ADA Curb Ramp New Construction Inspection Form (Perpendicular)

Nw 288 ter

24952.54

Nw carver st

PERPENDICULAR RAMP (PR)

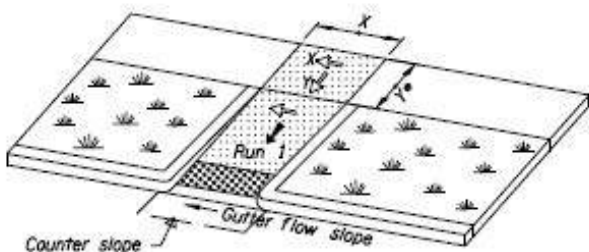
IITD tool joints in turn space
